MEMORANDUM

Re: Modifications to Design Approval for the Kensington Tower at approximately 89 E. 200 S. (PLNPCM2019-00786)

REQUEST: The Kensington Tower project previously received Design Review approval from the Planning Commission on November 13, 2019. The applicant has requested modifications to the approved design. These changes are required by ordinance to be reviewed by the Planning Commission as only minor modifications can be approved administratively.

NORTH FACADE MODIFICATION

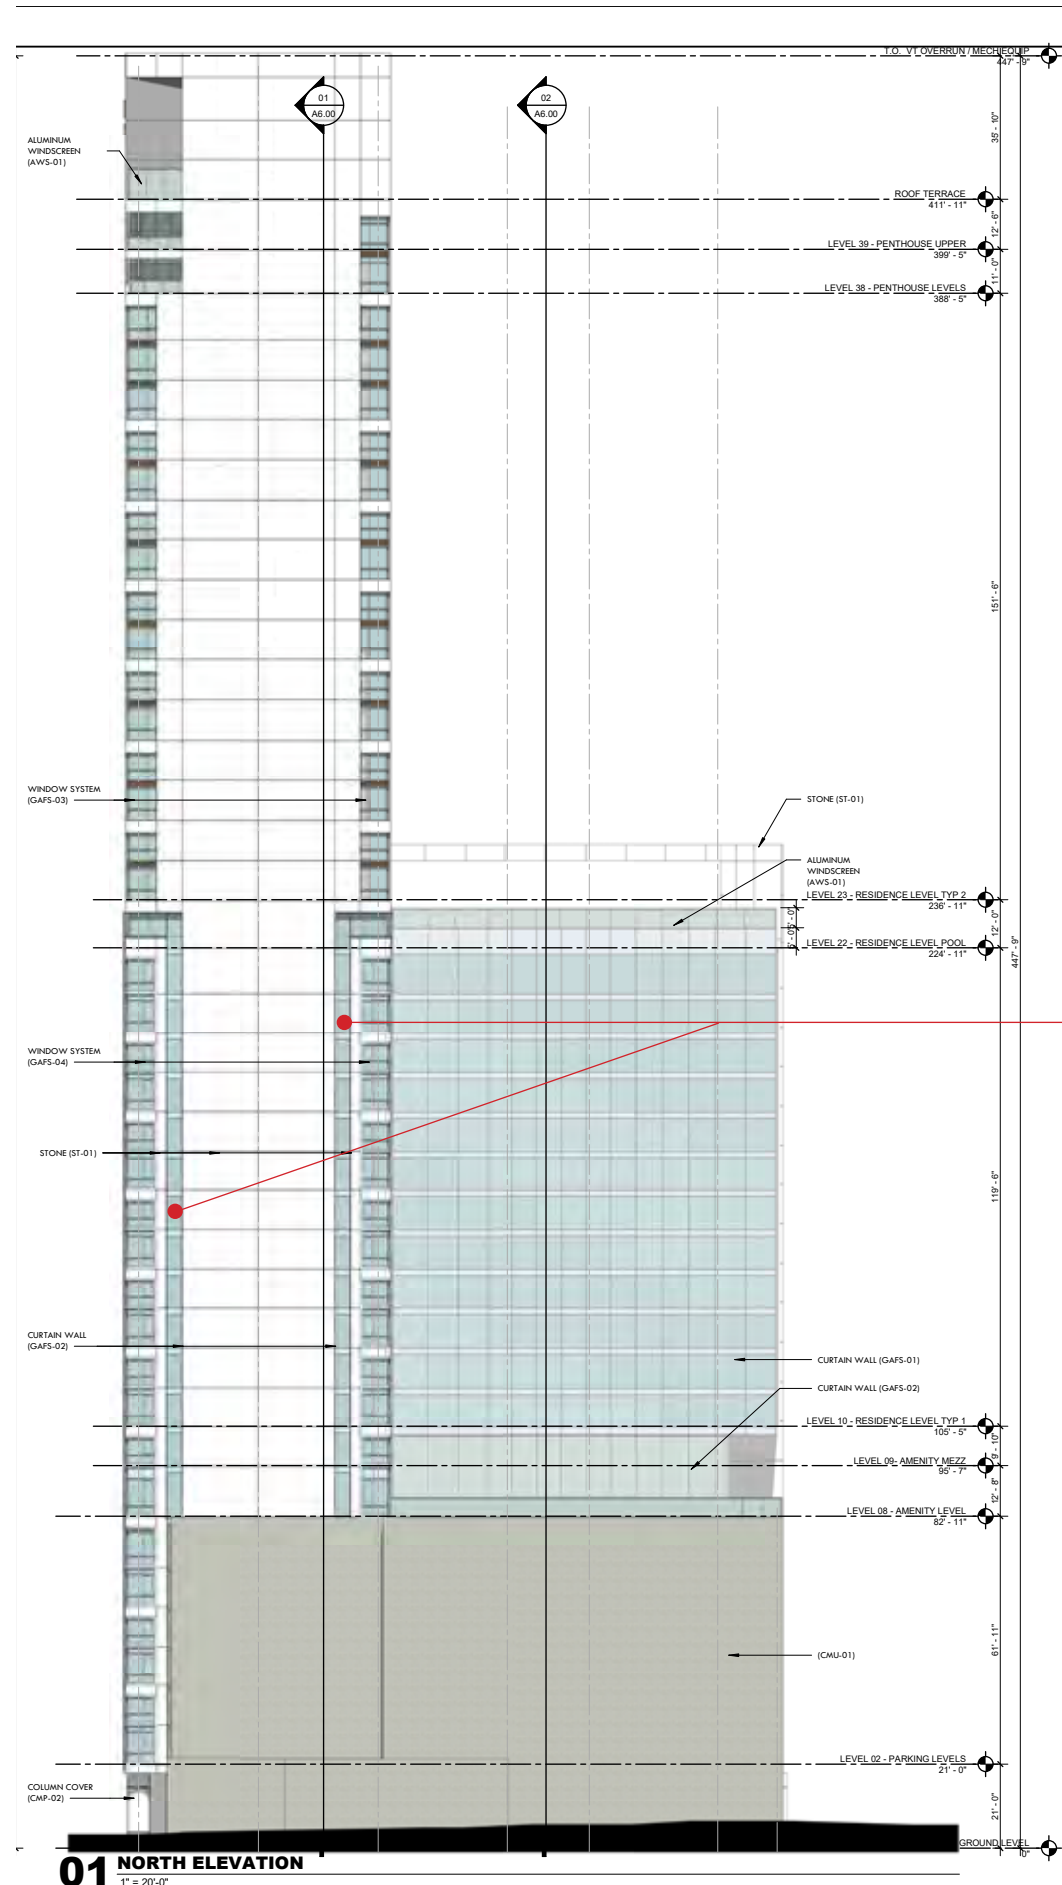
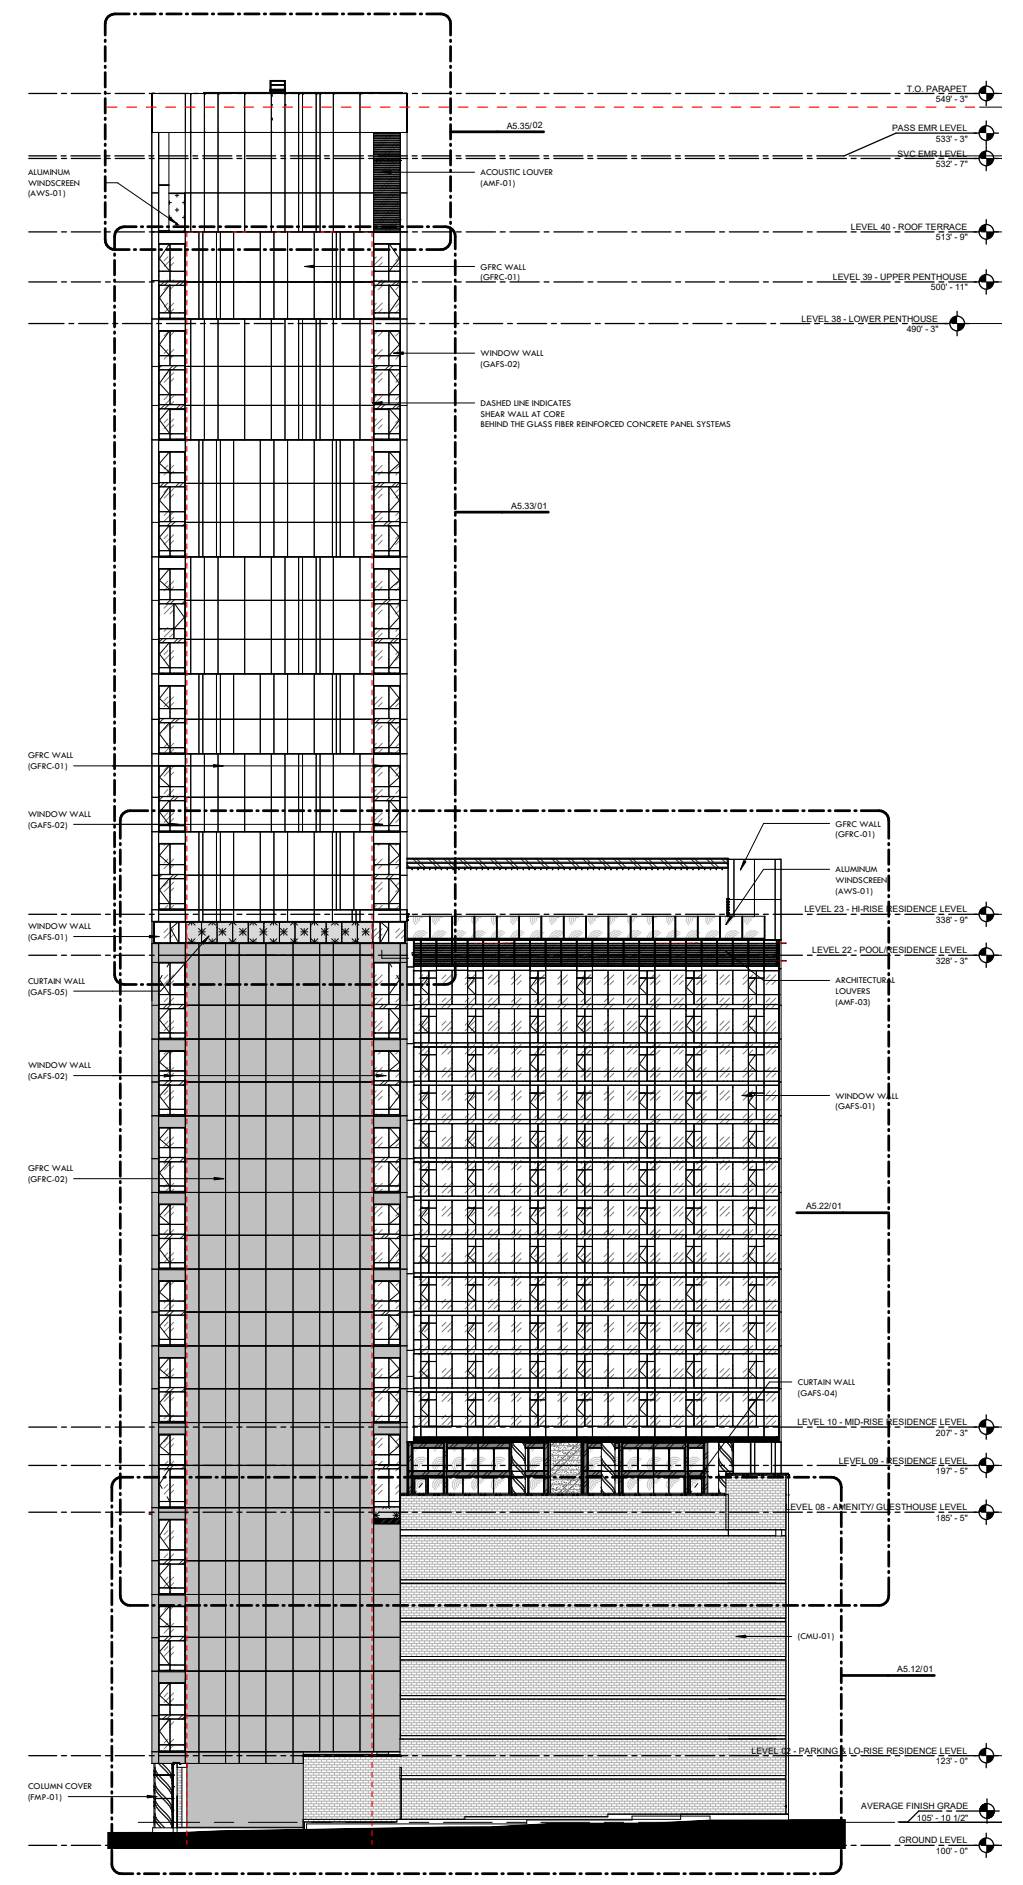
WINDOW SLOTS DELETED TO
MEET ALLOWABLE OPENINGS IN
ACCORDANCE WITH CODE

01 OVERALL LEVEL 08 - AMENITY LEVEL & GUESTHOUSES

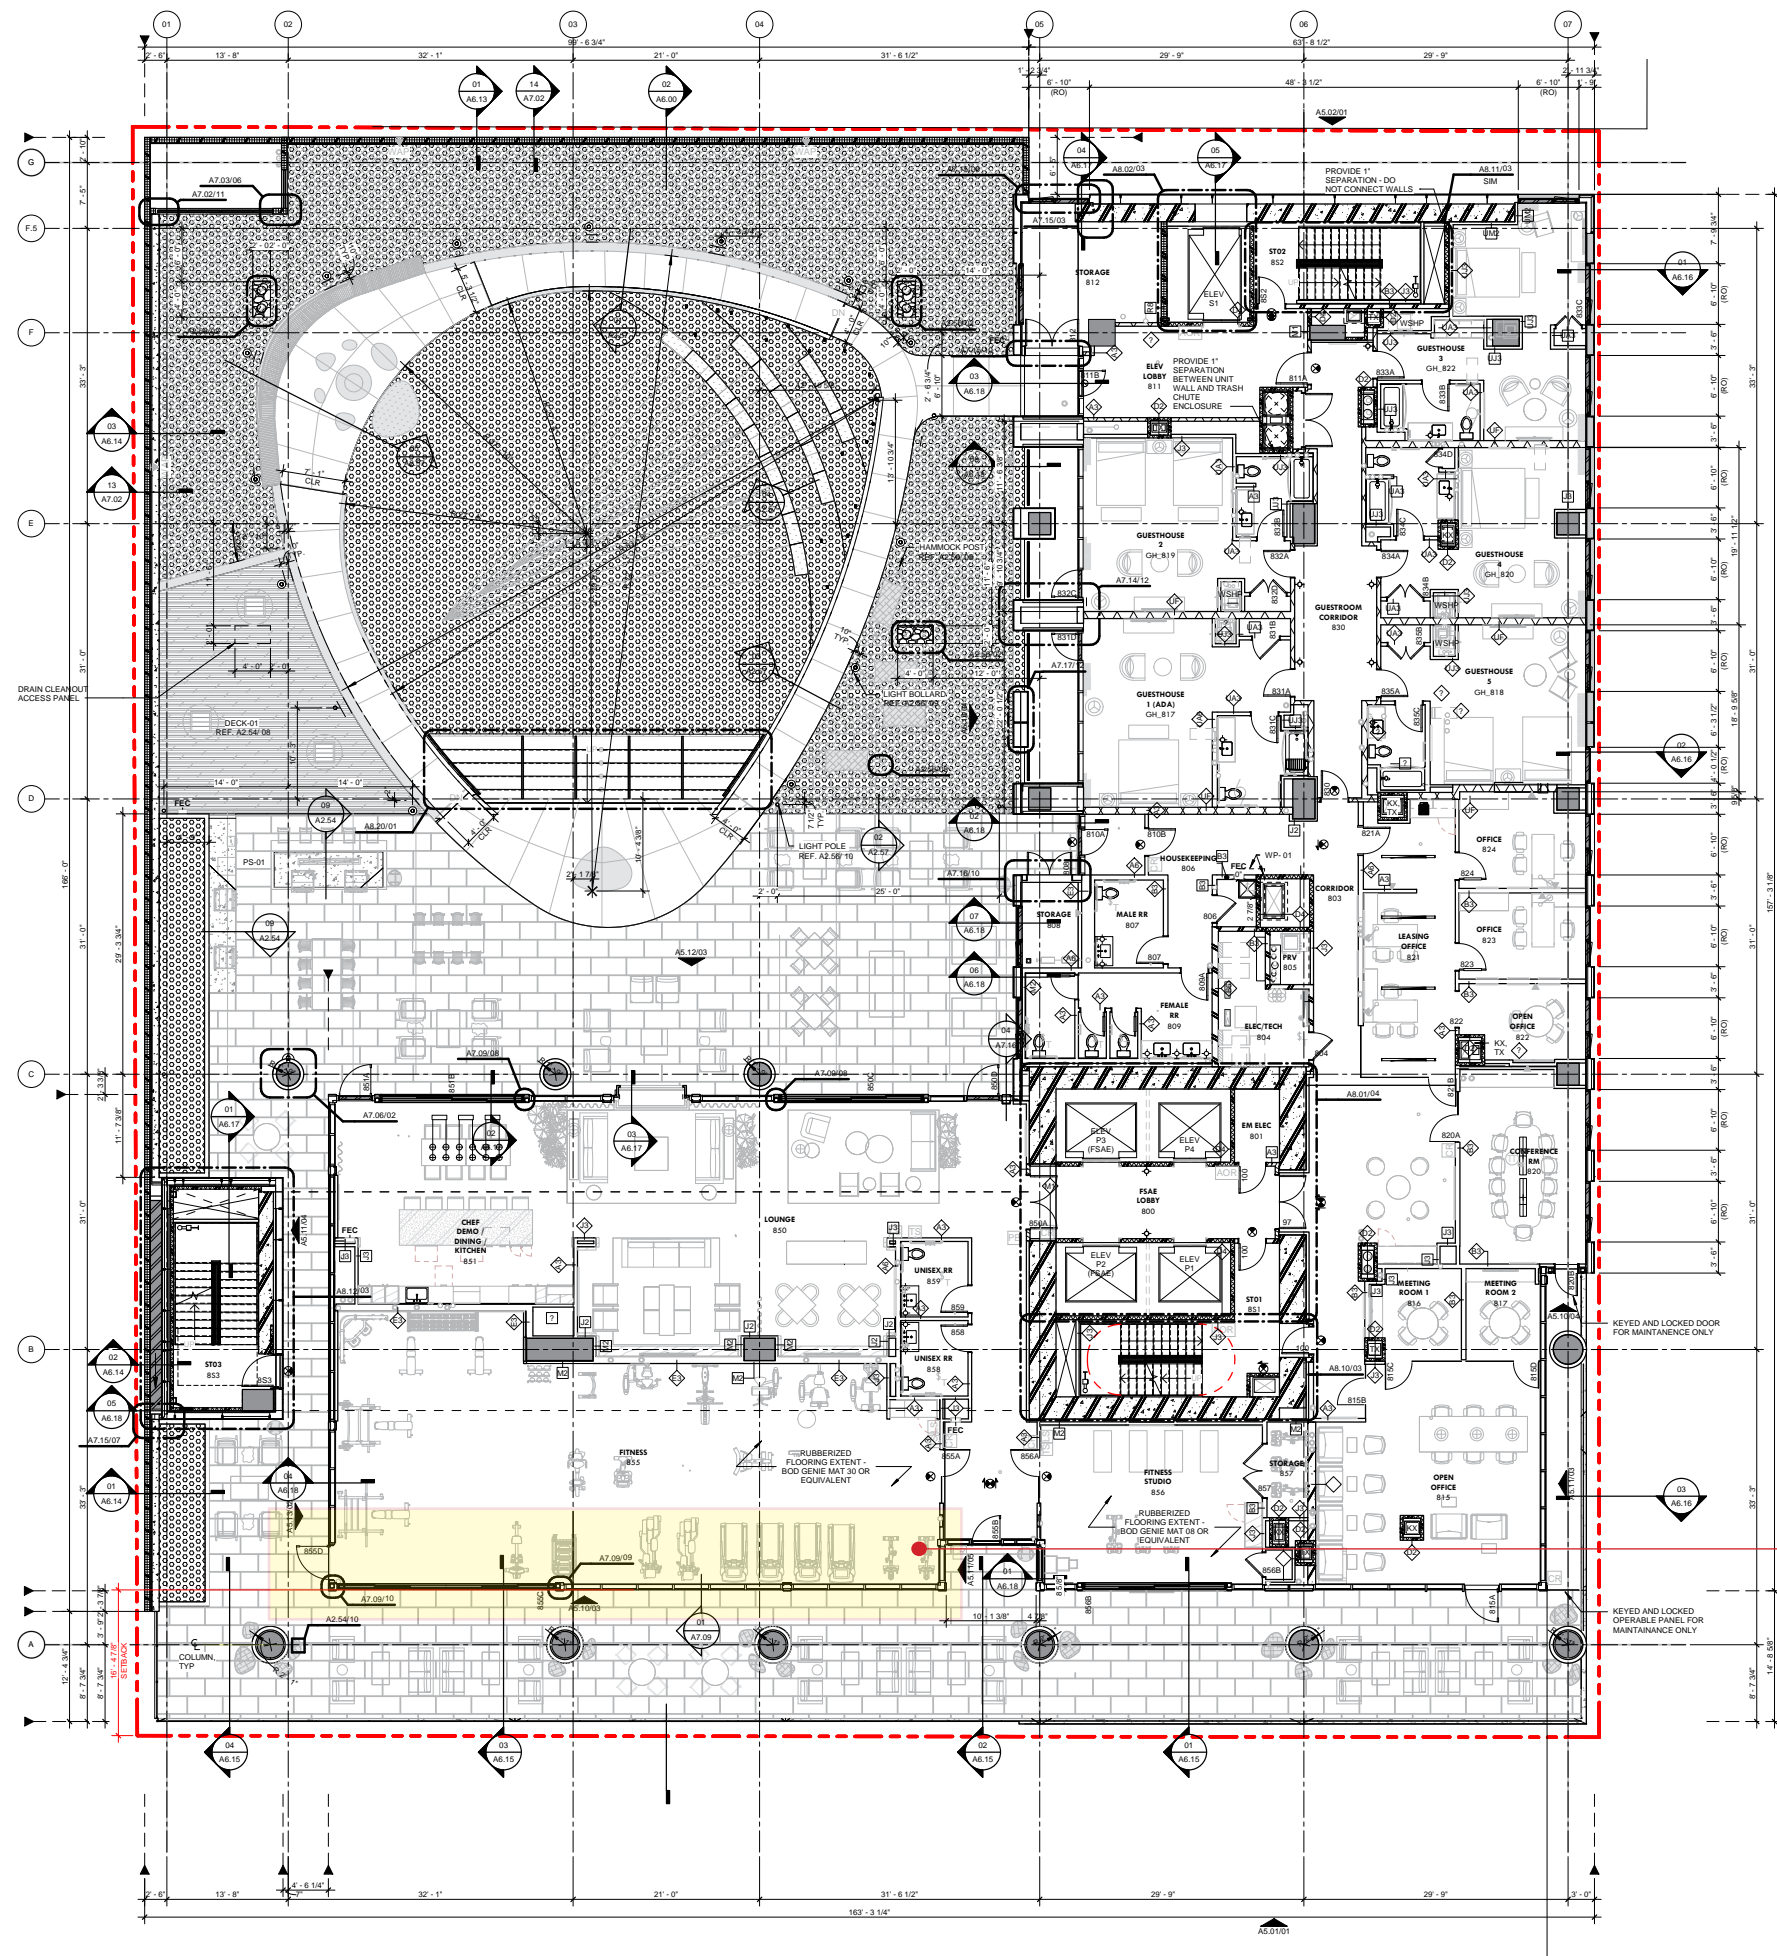
SETBACK REDUCED TO
—ACCOMMODATE
—PROJECT PROGRAM
